August 15, 2014

Please accept the following comments on the Figure Eight Beach Homeowners Association's terminal groin project proposal on behalf of the N.C. Coastal Federation.

I. Newly Proposed Alternative Mandates Supplement to the draft EIS

Figure 1: Shoreline changes between 2008 and 2013 at north end of Figure Eight Island. Source: Google Earth.

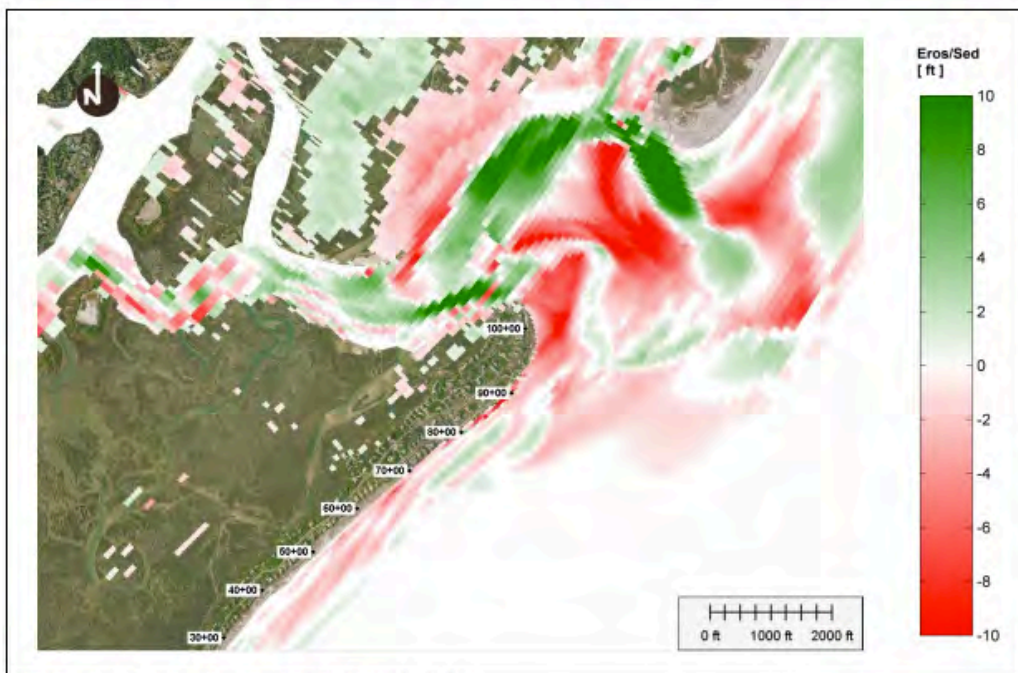
The shoreline and inlet configuration have significantly changed from the 2006-07 configuration that the CPE used as a baseline for its modeling. Figure 1 illustrates the substantial breadth of change and the natural accretion of about 60 acres in the sand spit at the northern end of the island. The current shoreline and inlet configuration were not predicted to occur by the original Delft3D model under the No Action alternative (see

Figure 2) which begs the question as to why these models are considered to be of any value in making management decisions regarding the inlet. Figure 2 illustrates the configuration of Rich Inlet in 2011 and 2012 if no action was taken to control erosion. The illustration based upon the computer simulation indicates that the entire beach would be eroded away in front of the houses at the inlet. The model failed to predict that the beach would in fact not erode, but gain sand and contain approximately 60 acres of new land that the computer model failed to predict.

Figure 1. DEIS and modified terminal groin layout 5D.

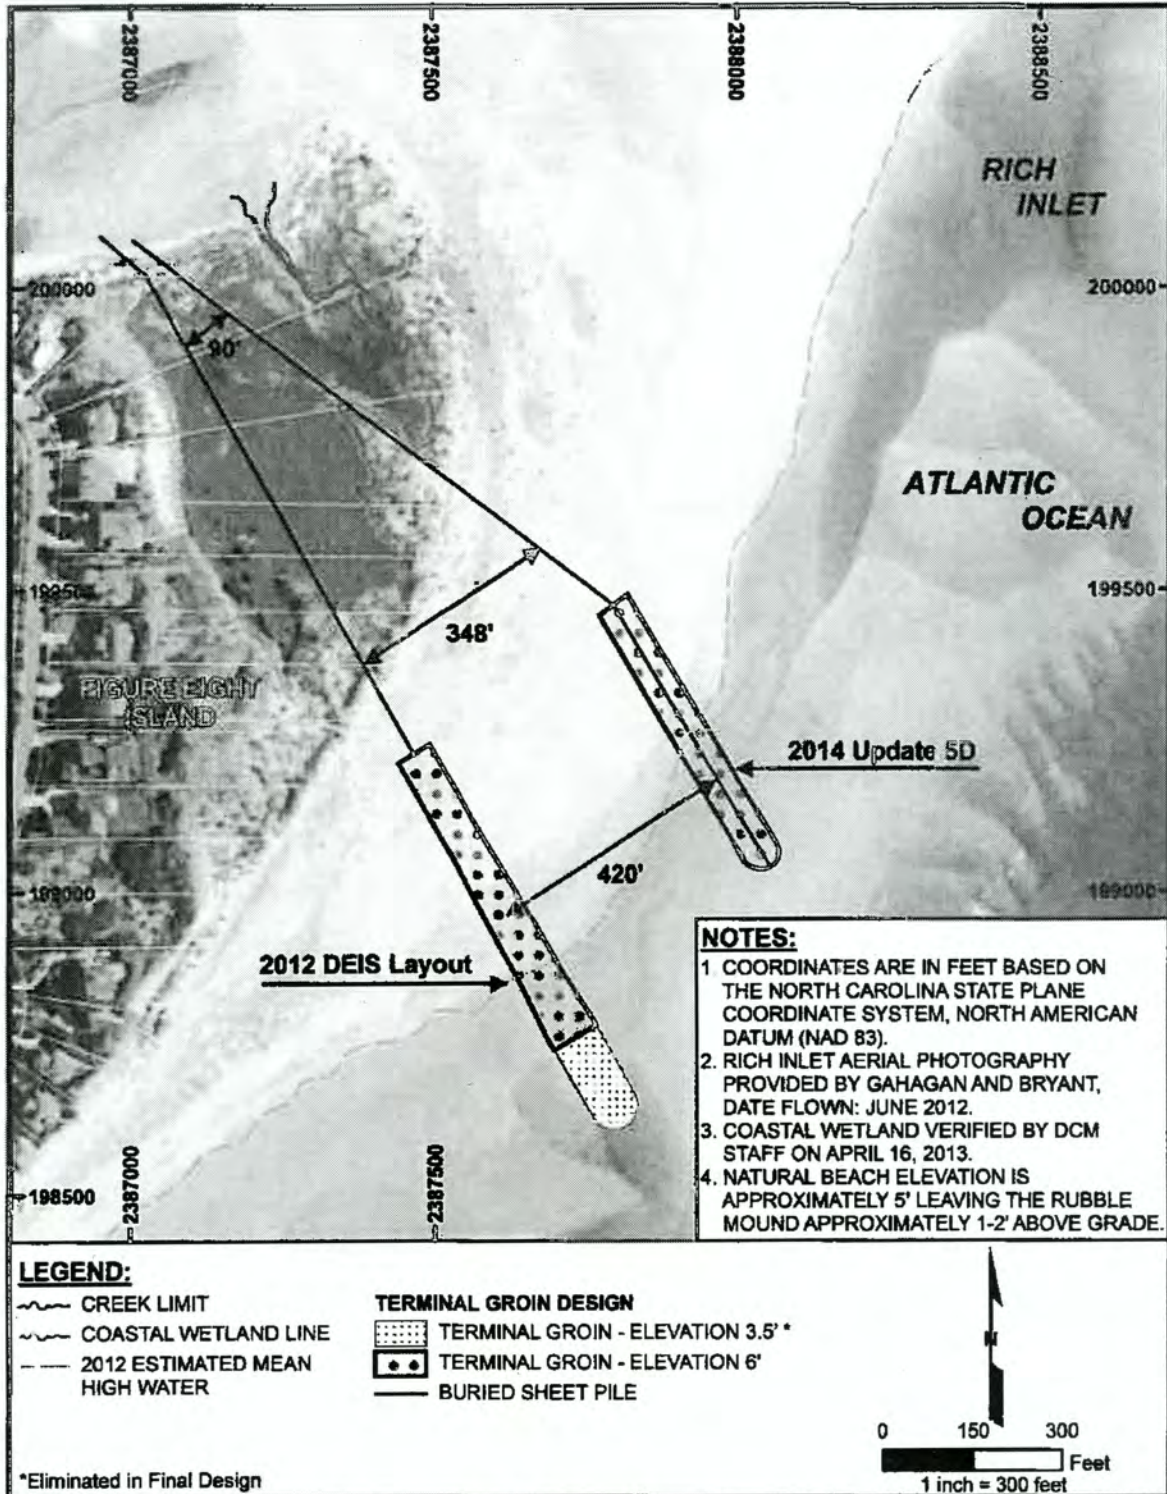
As we stated in our previous letter, the new preferred alternative design is significantly different from any of the alternatives described and evaluated in the original DEIS. Some of the major differences between the new preferred alternative and the previously preferred alternative include:

- (1) The new structure is longer, bigger and more expensive.
- (2) The portion of the structure that has six feet of elevation is longer and more substantial.
- (3) The footprint of the structure is new and angled.
- (4) Modeling for the new alternative is misleading because it is based on the shoreline position in 2006-07, rather than on the newly accreted and current shoreline position.

- (5) The direct disruption of the federally designated “critical habitat” is greater than it was with the previous preferred alternative given the proposed location of the groin right in the midst of prime nesting and foraging habitat.
